## ADDENDUM #01

ACES at CHASE

STATE PROJECT NO. 244-0044 MAG

6. **ALL Bidders** should review and incorporate the **attached Bulletin #1 dated December 16, 2025** prepared by **S/P+A** and their consultants. This Addendum includes:

E400-5

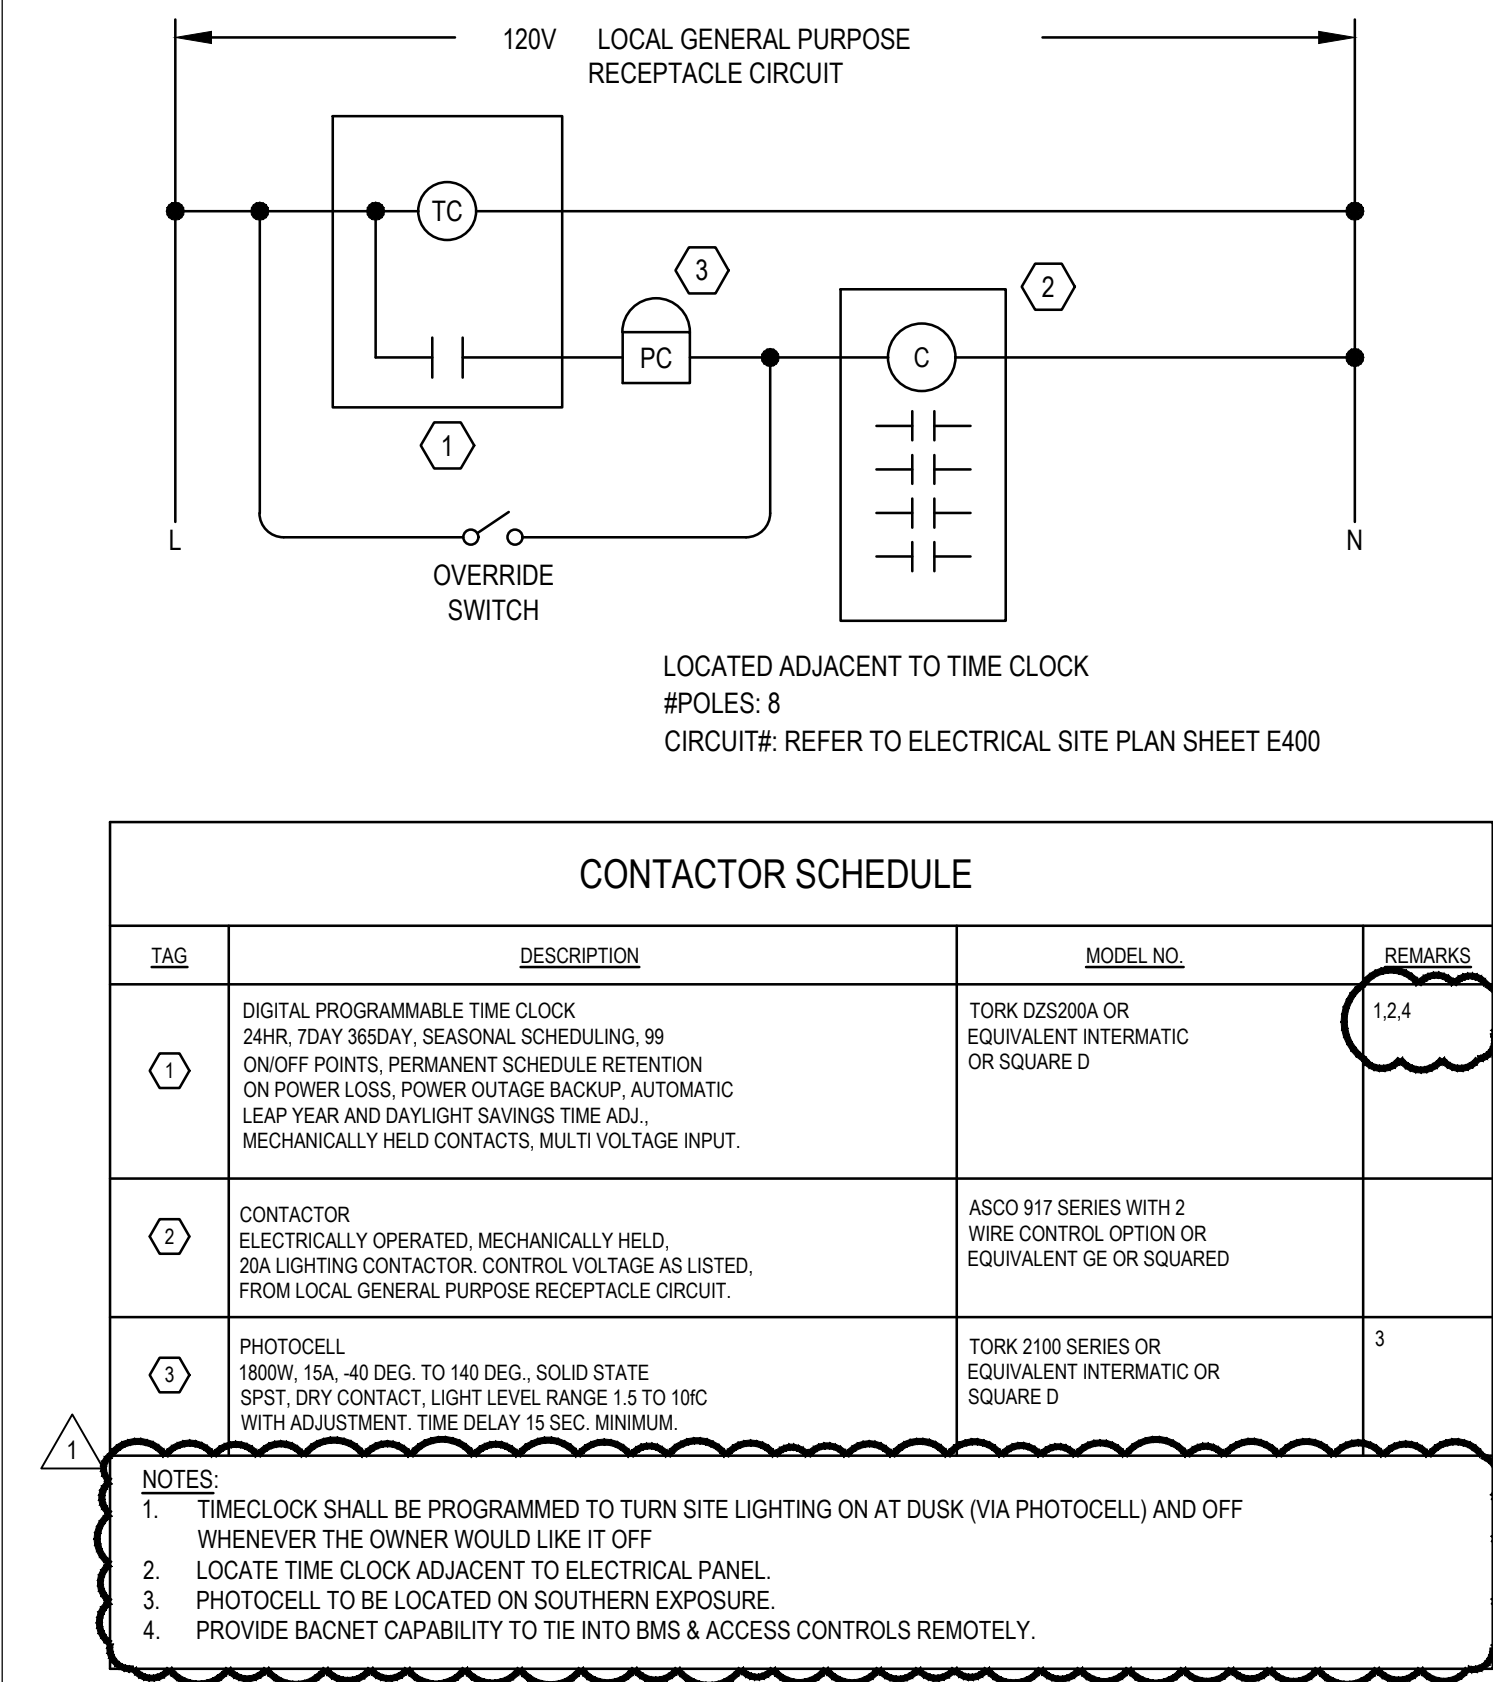
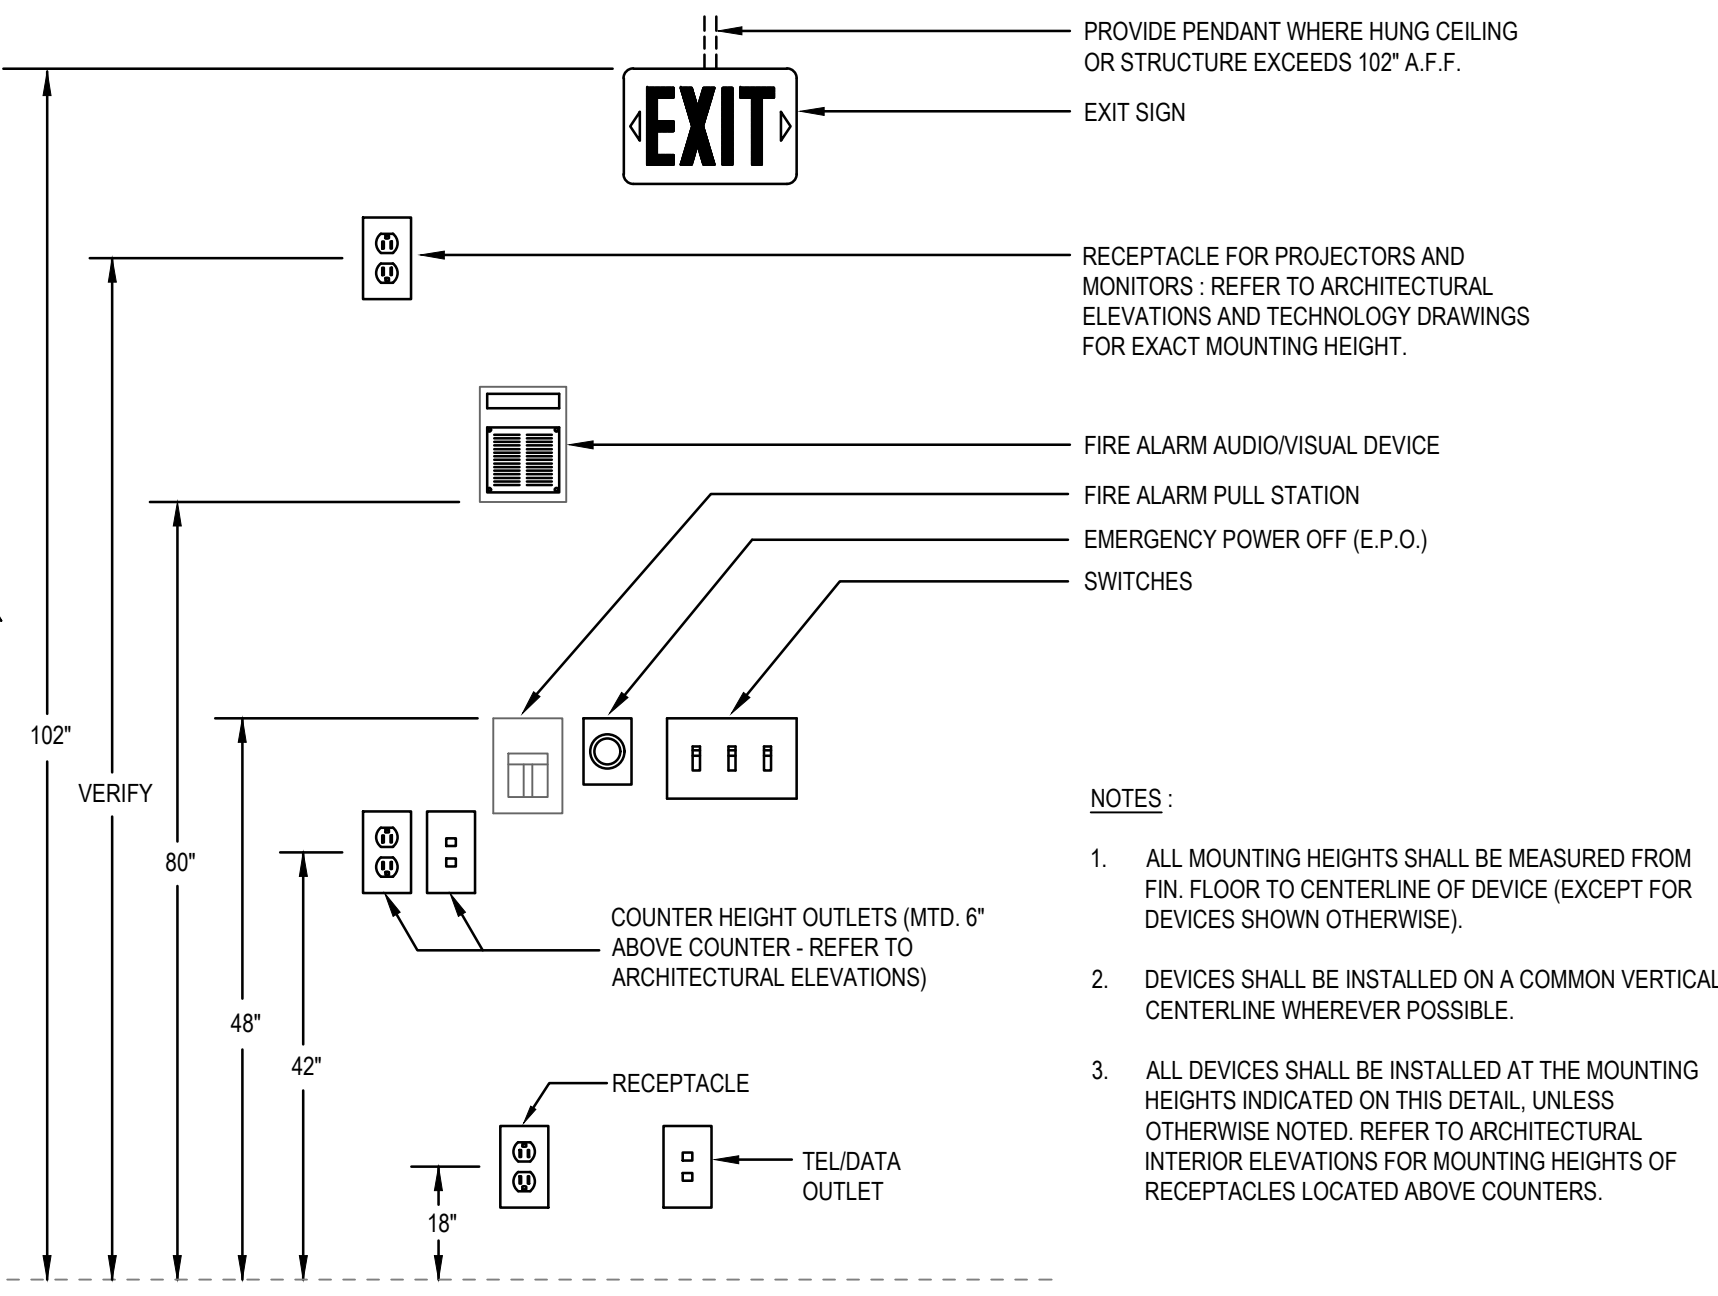
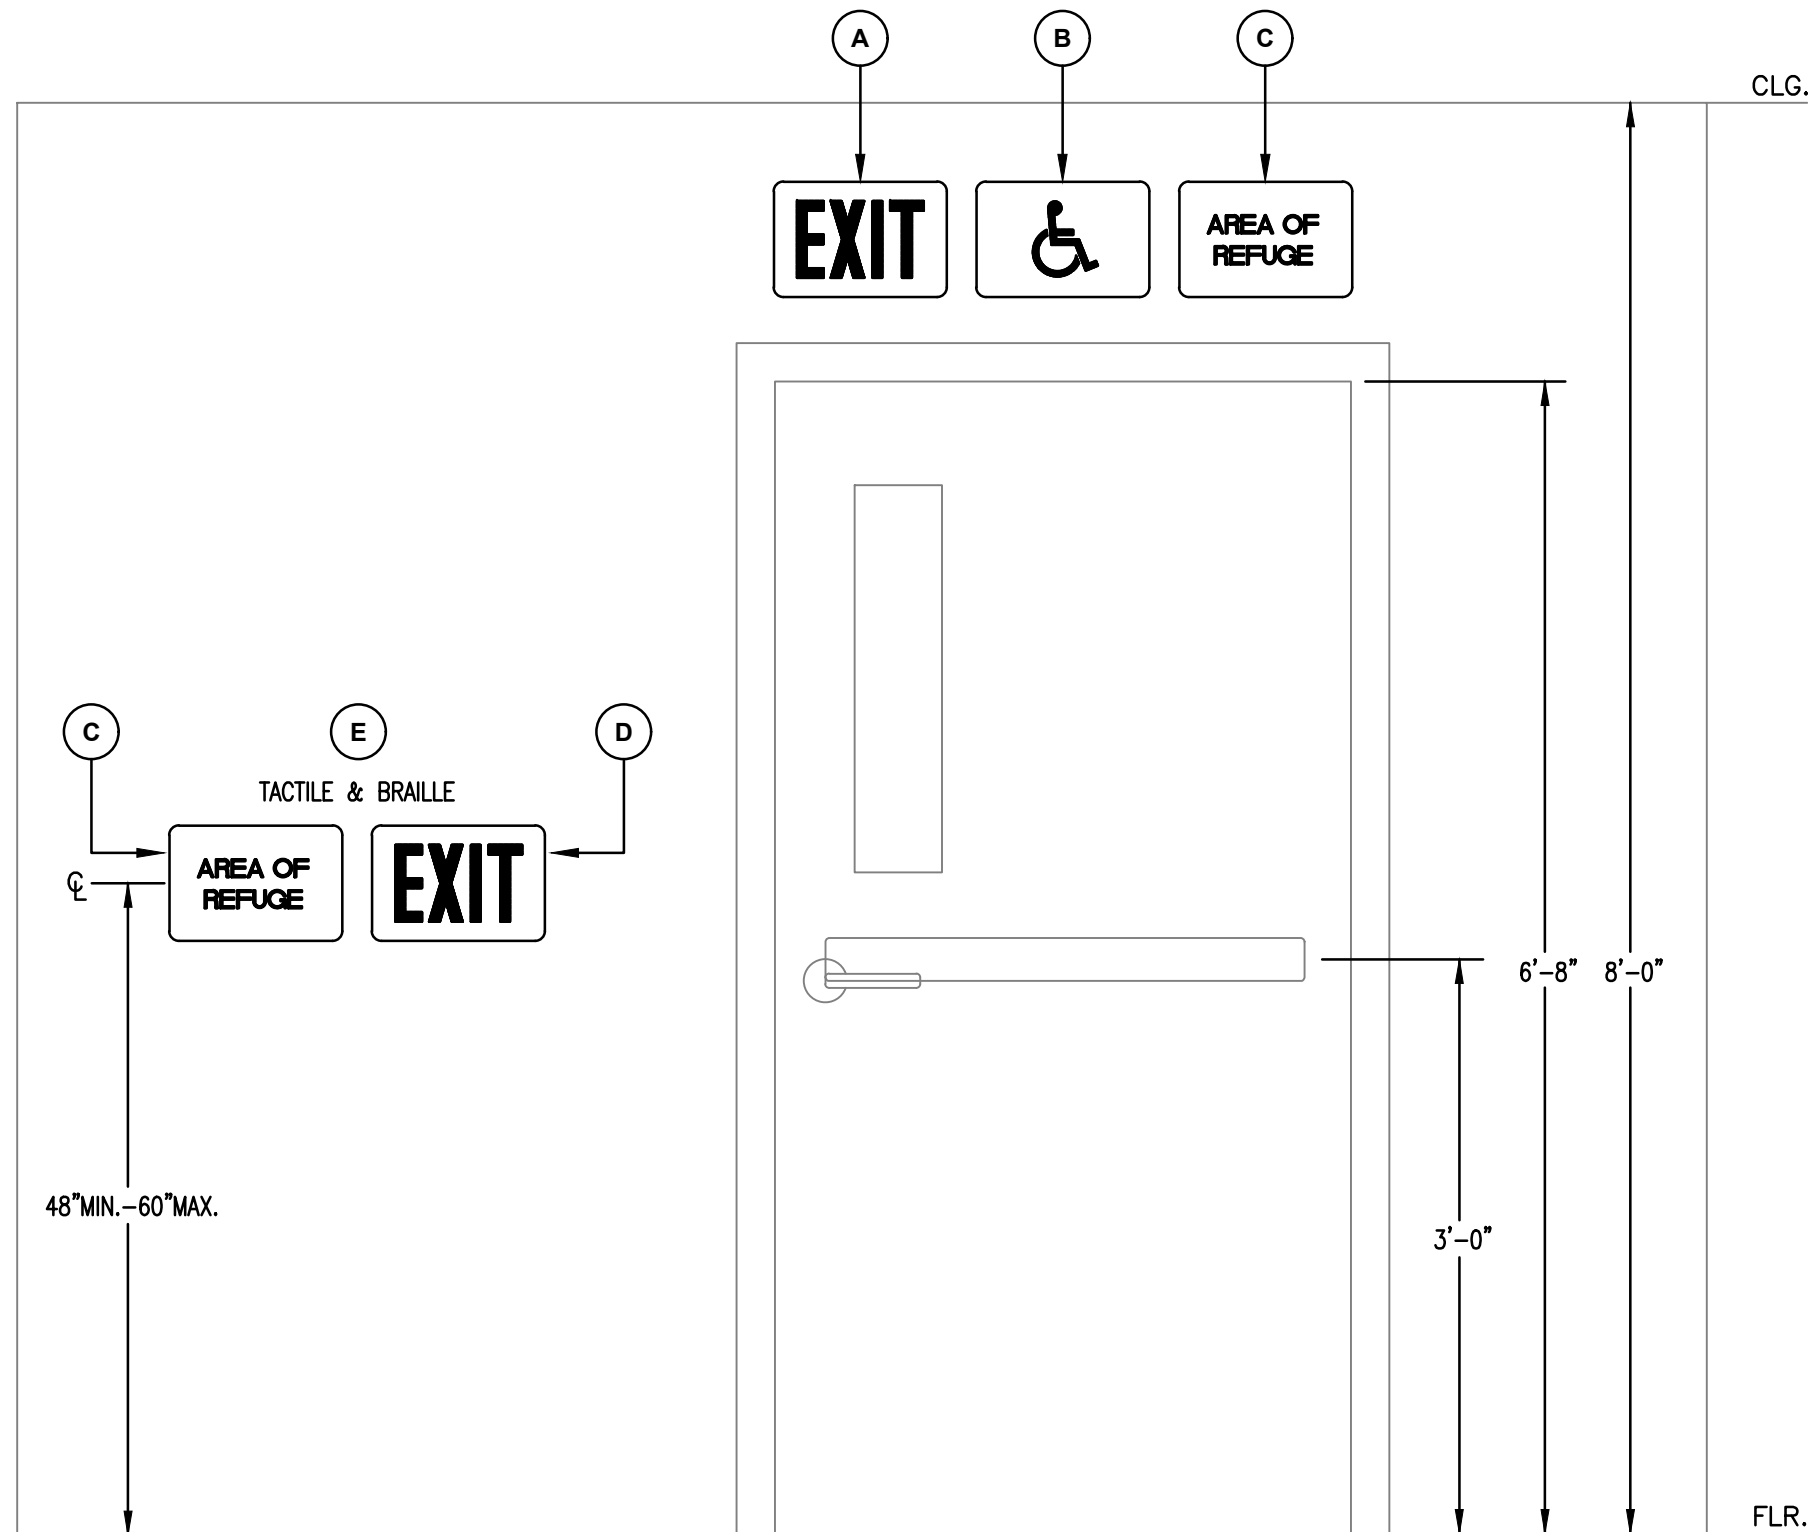
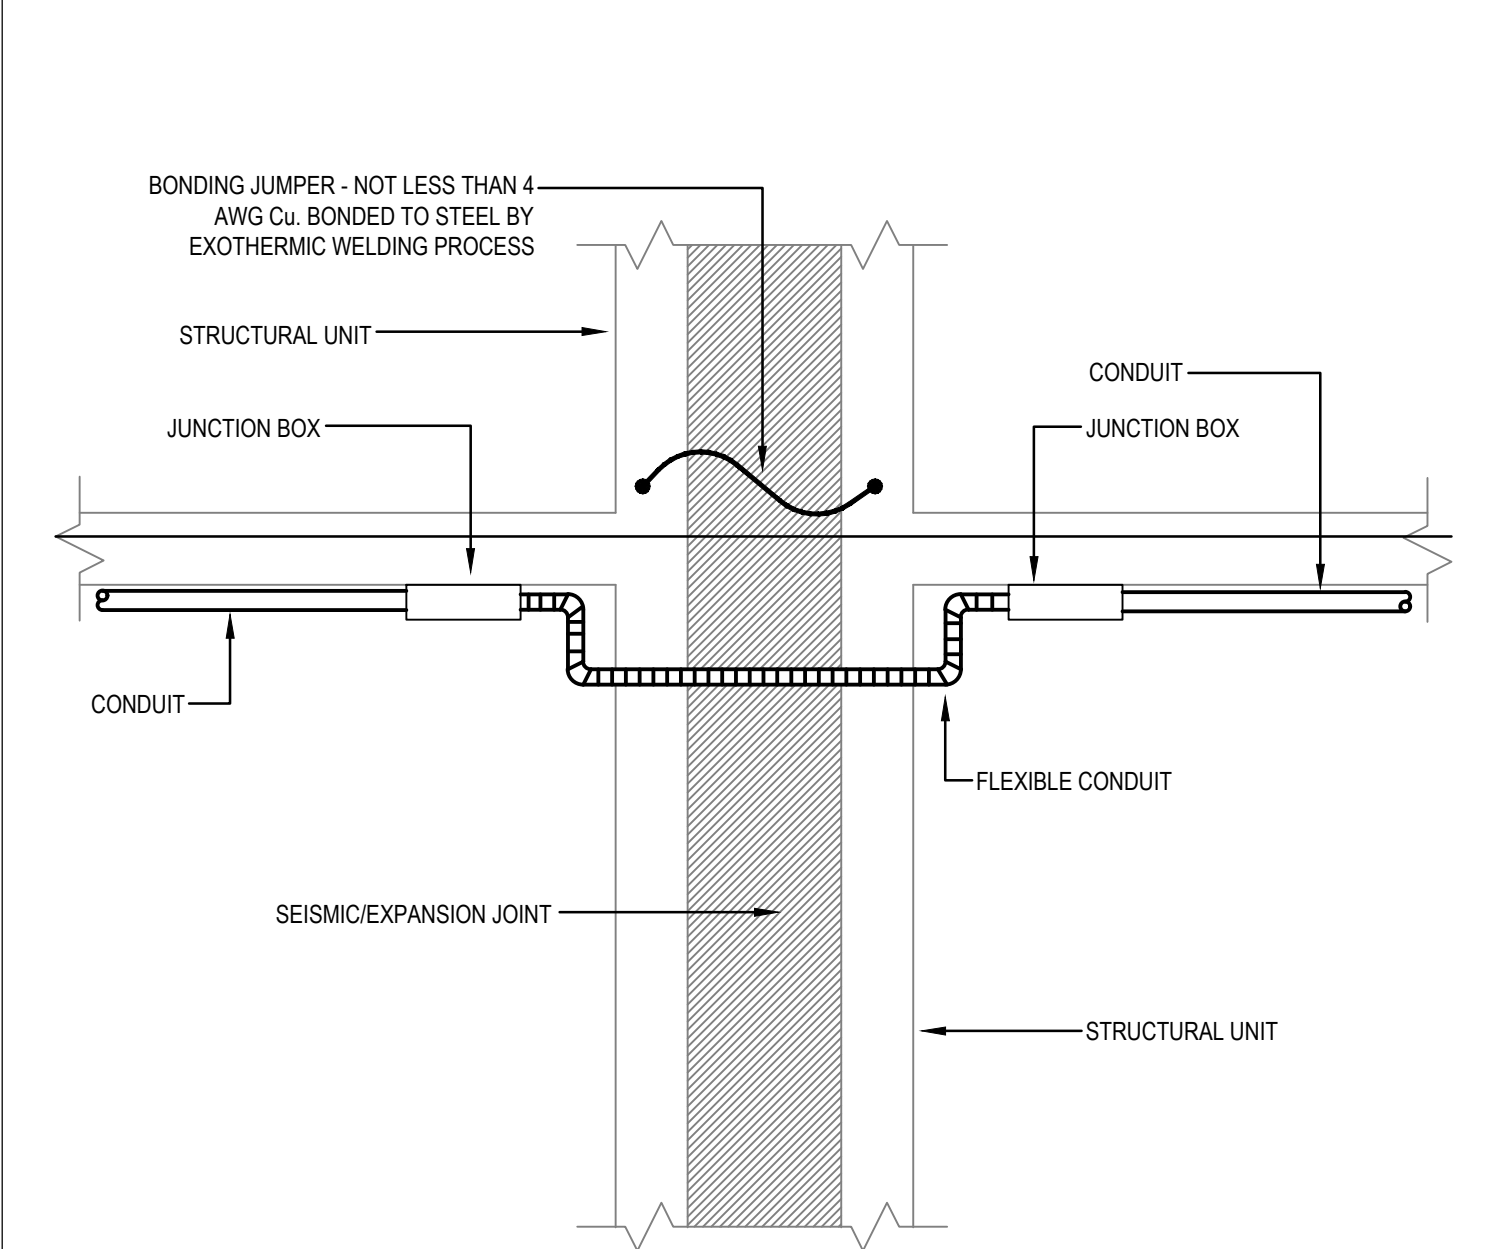
- Building 5, DRAWING E400-5, BUILDING 5 – DETAILS, delete in its entirety. A new DRAWING E400-5 has been added and is attached as part of this bulletin.\* *(Per Cx)*
